**SECTION 009113
ADDENDUM NUMBER 3**

1.02 PROJECT: GRAHAM CREEK AG BUILDING

Re: Graham Creek Ag Building - RFI responses to questions received in writing, Addendum 03

1 LIGHTING PLAN
E1.1 SCALE: 1/4" = 1'-0"

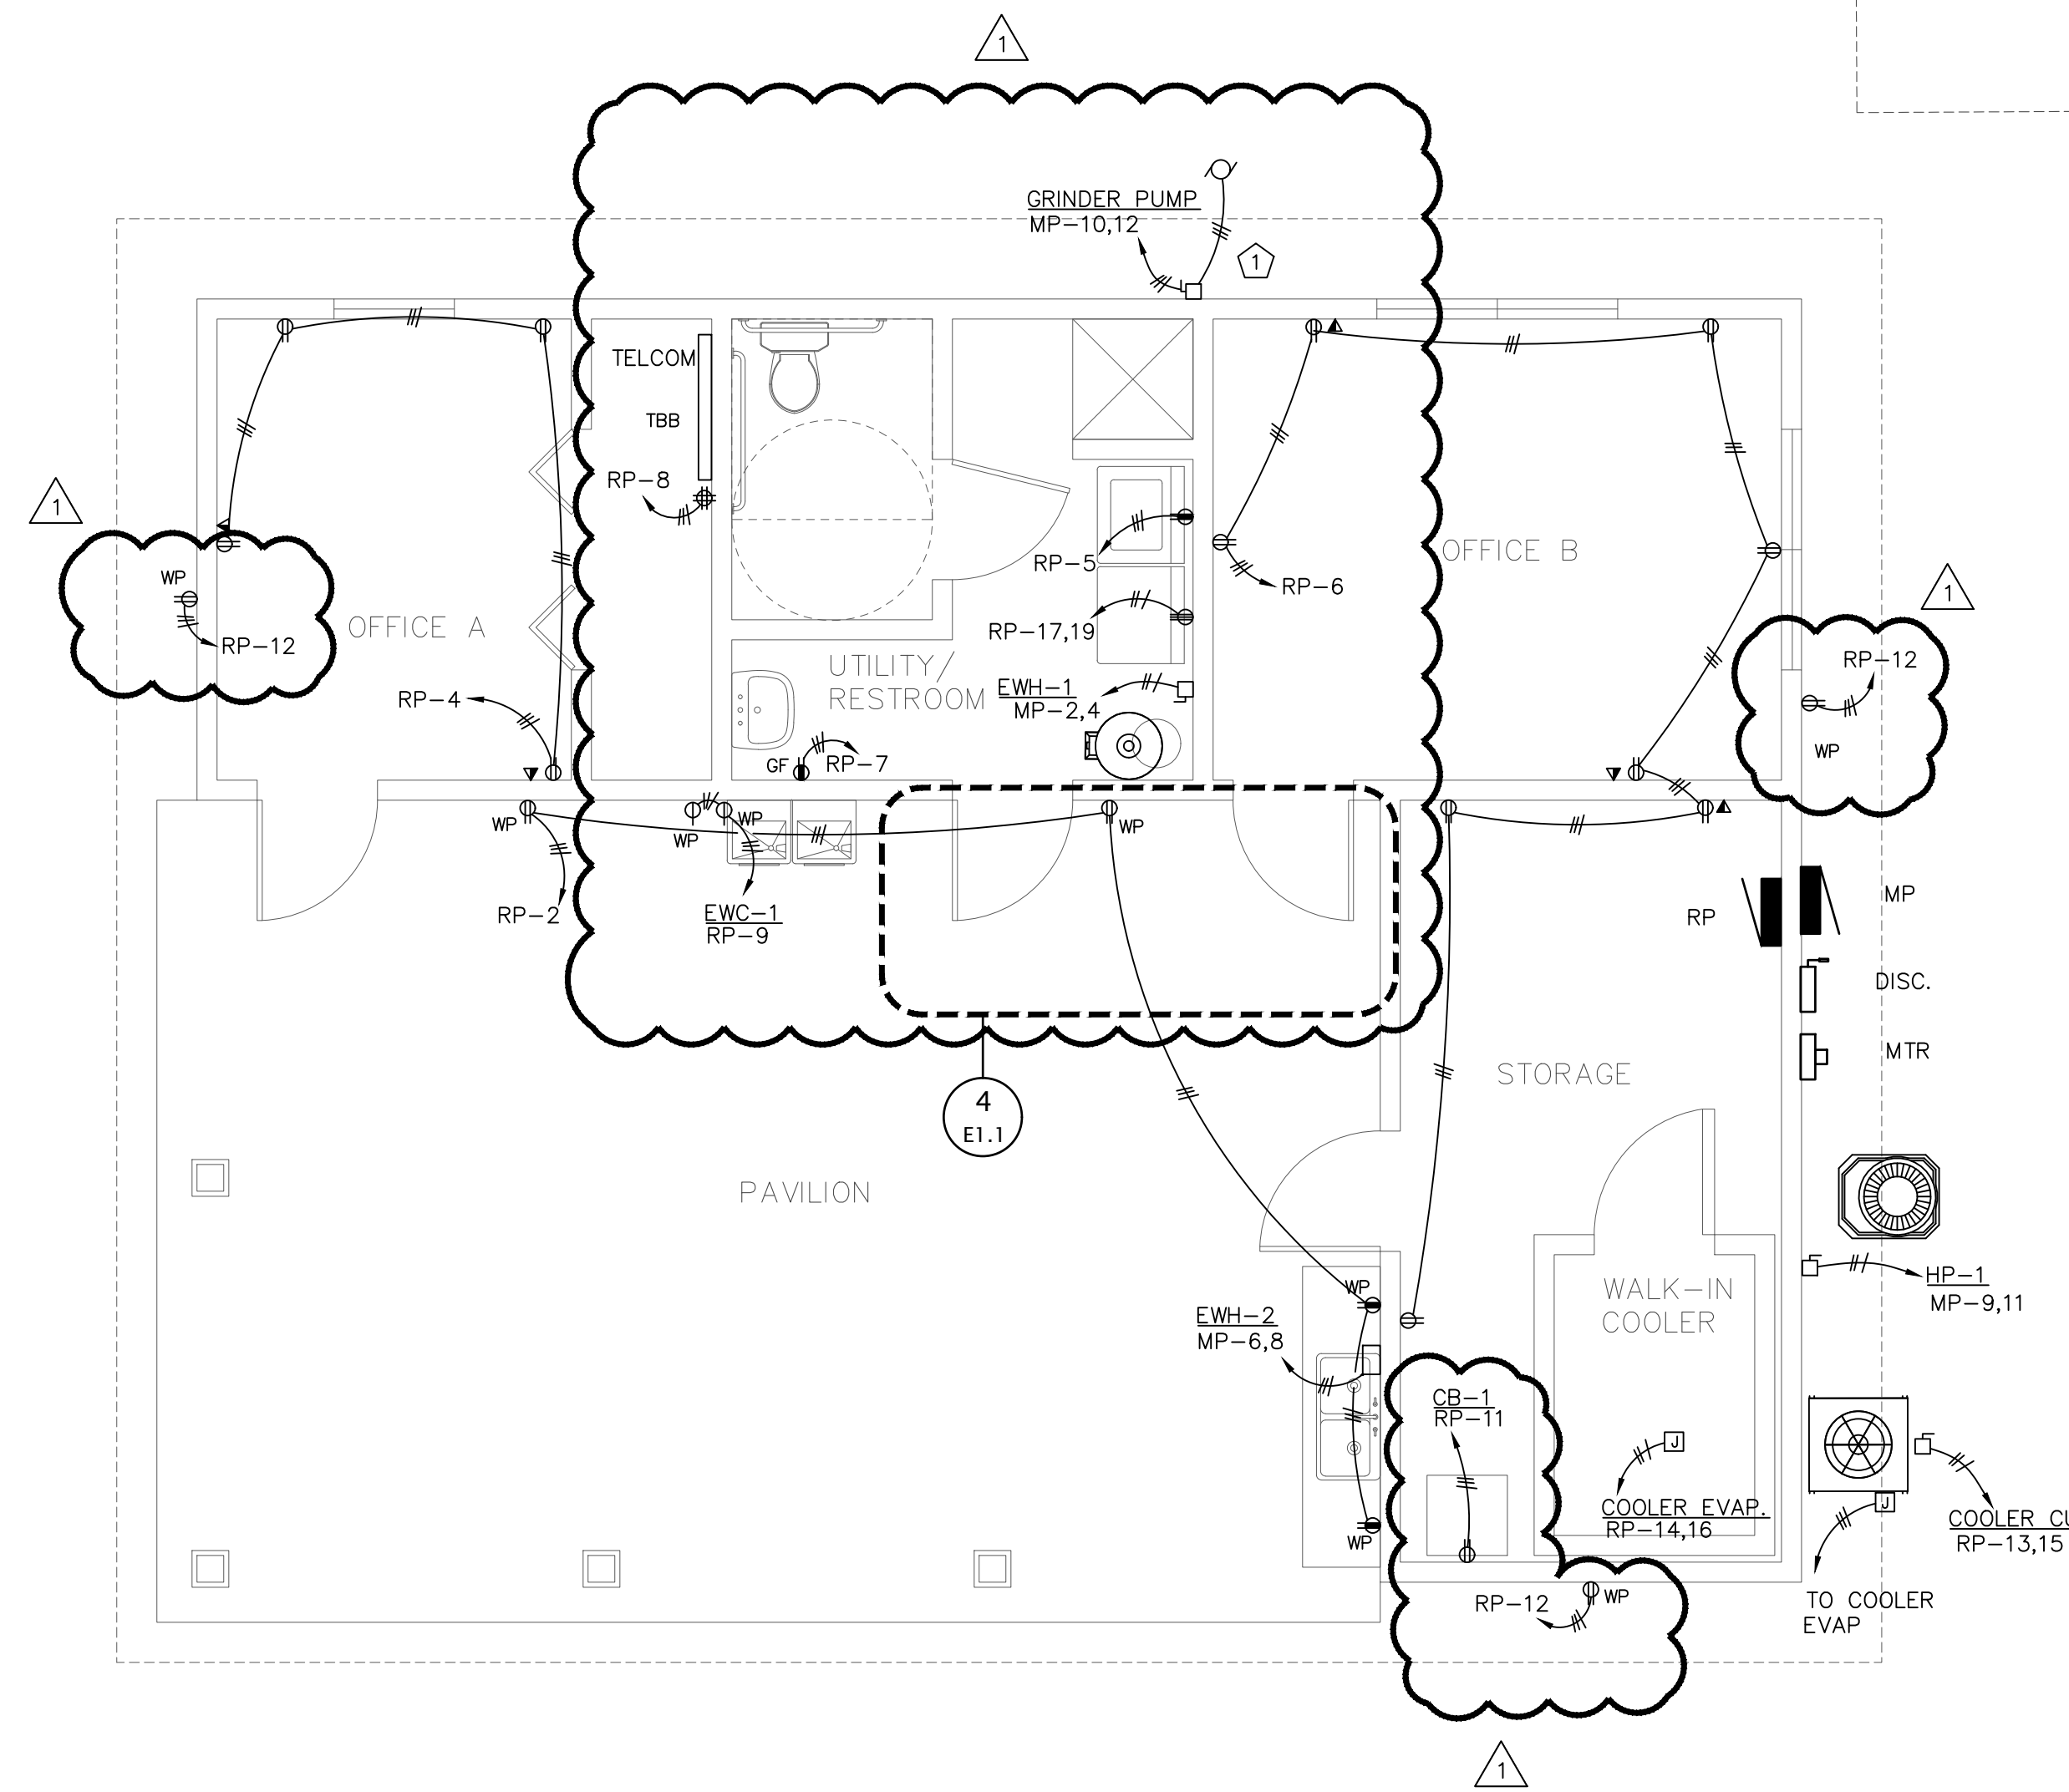
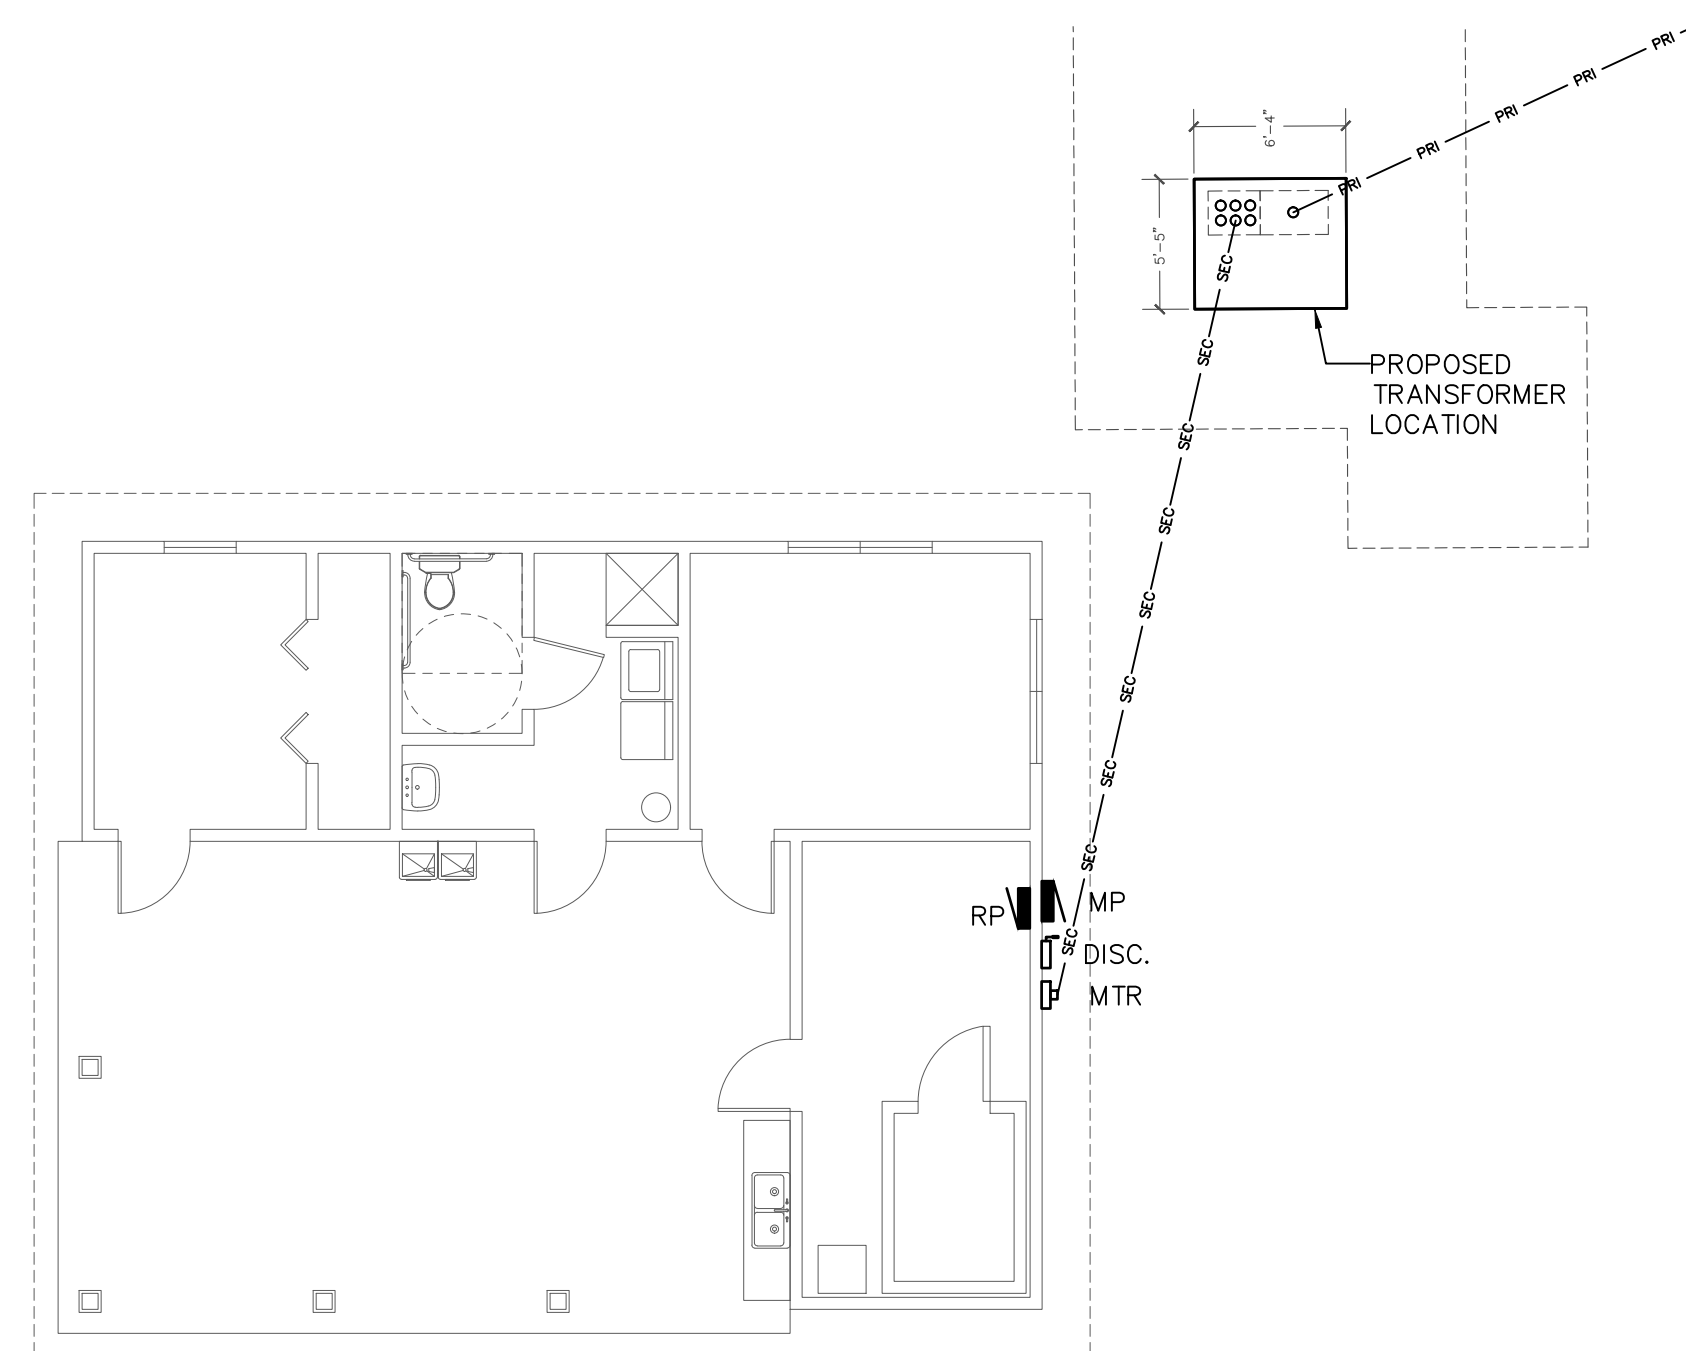
- 17) Who is responsible for pulling the data / cable drops and making the terminations.
 - a) The GC is responsible for wiring the building with the data / cable drops as shown on page E1.1.

1 PLUMBING PLAN
 P1.1 SCALE: 1/4" = 1'-0"

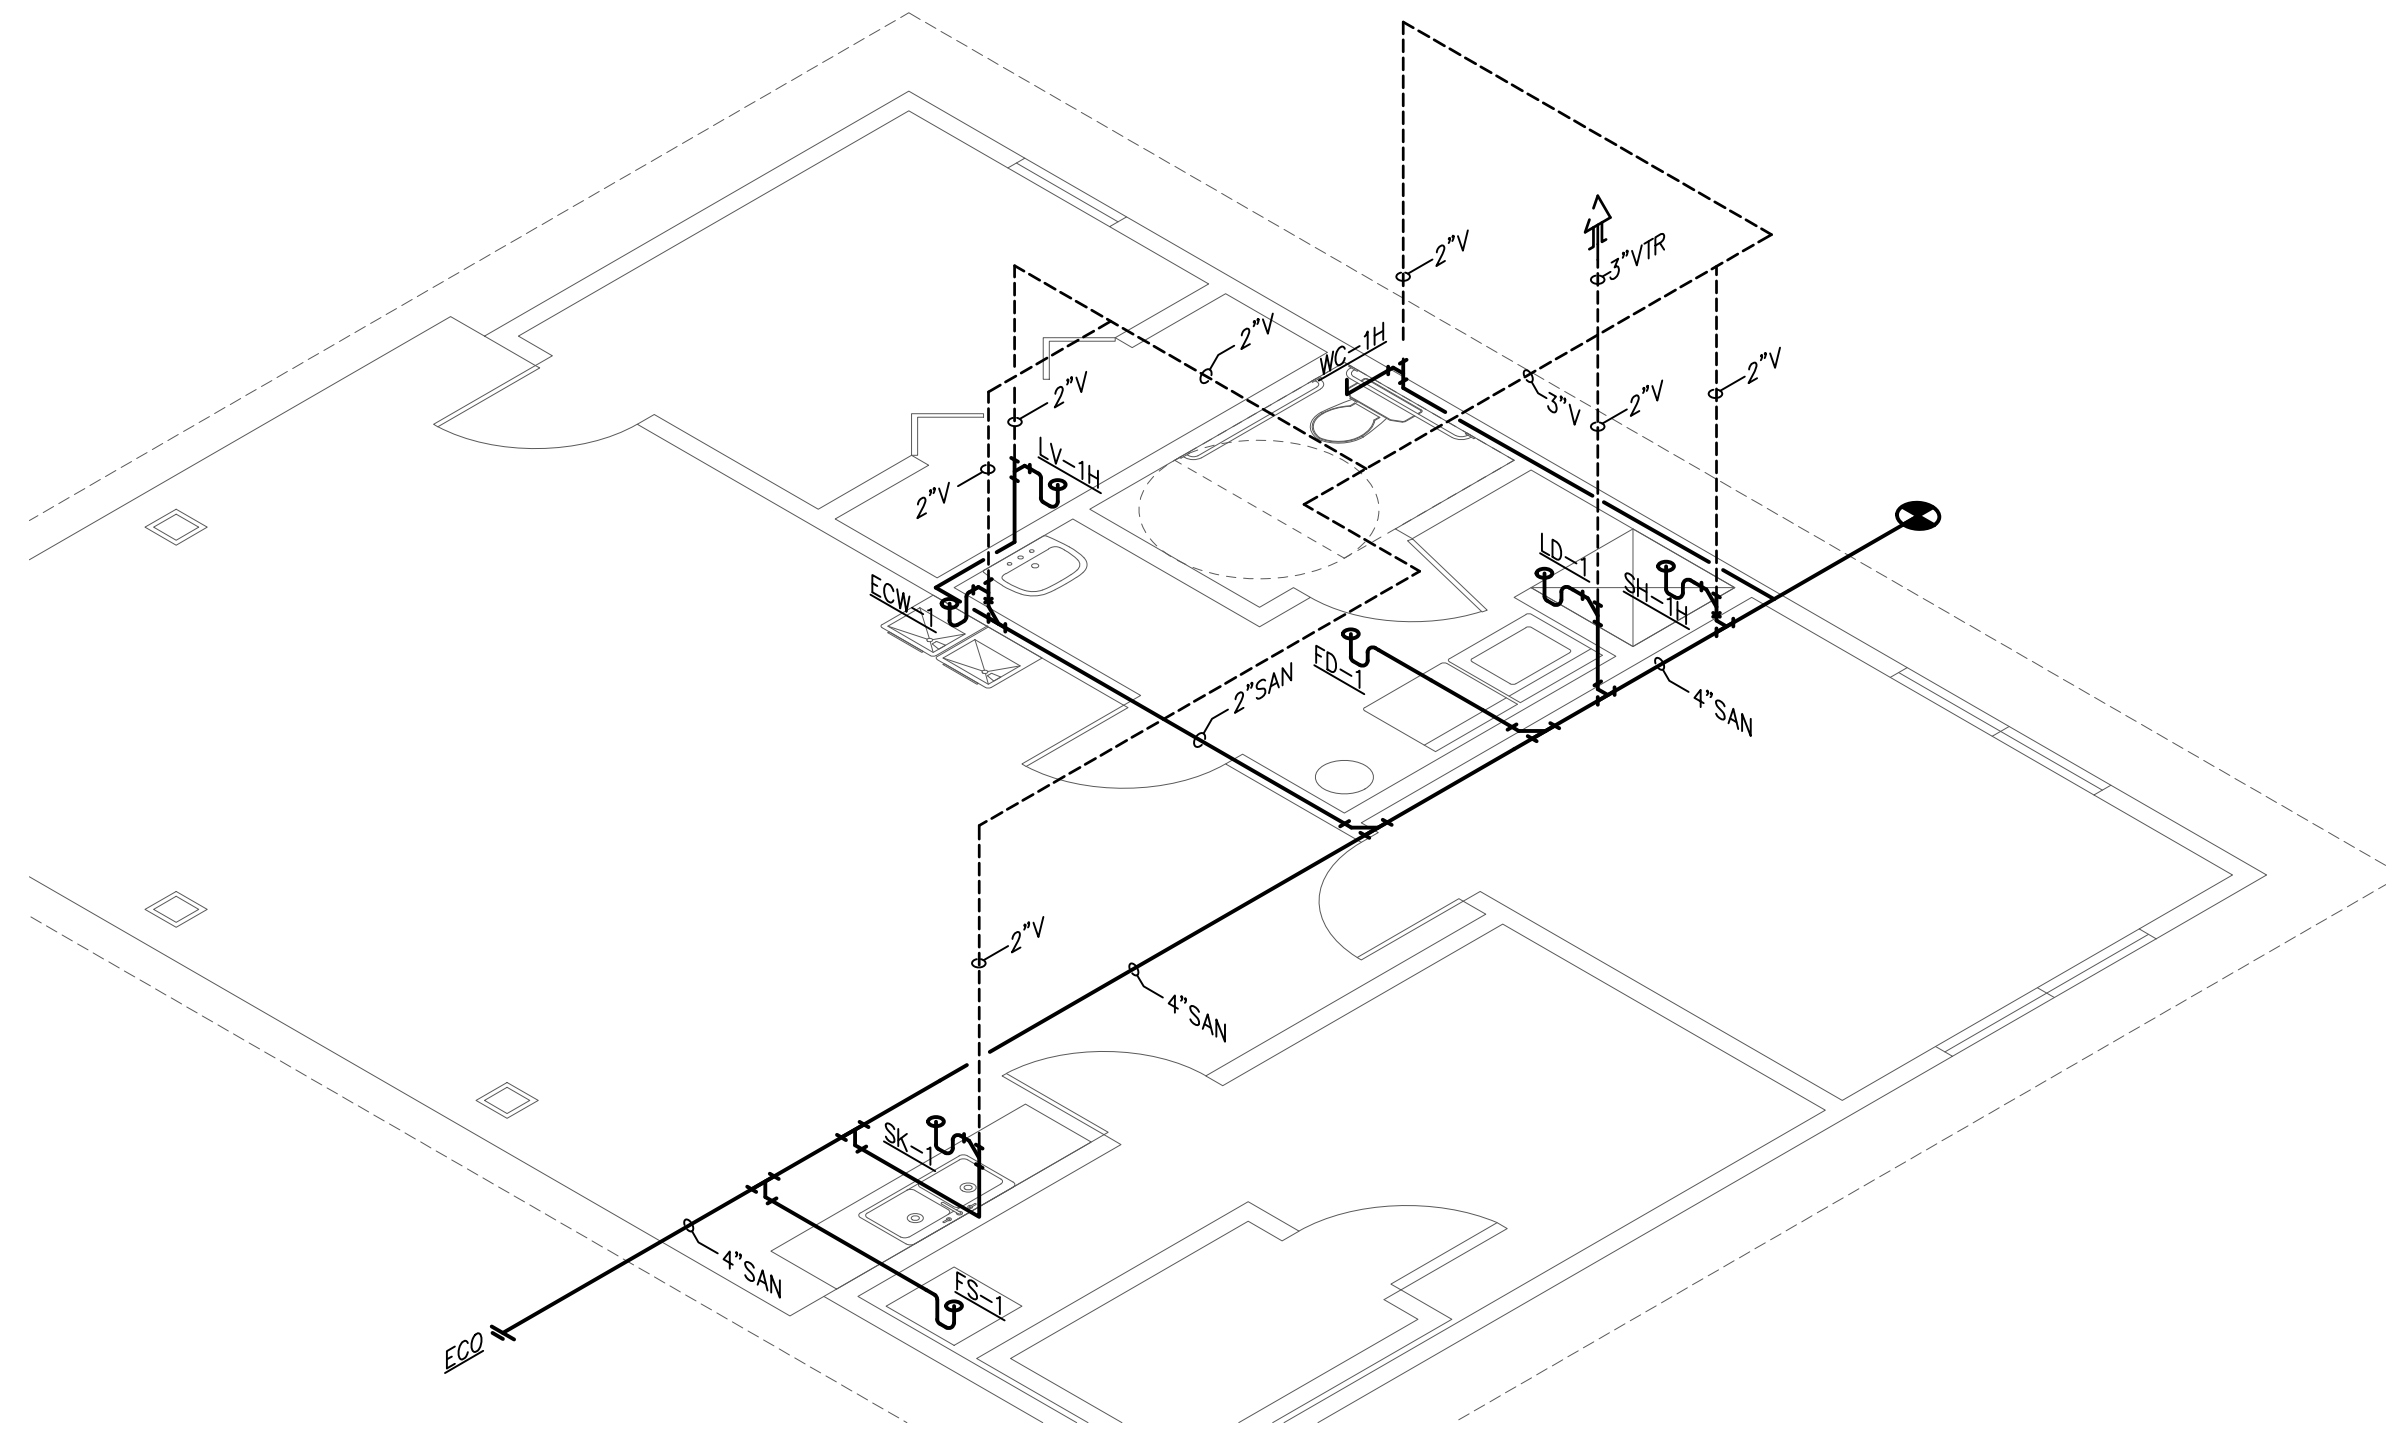
ENTIRE SHEET REVISED
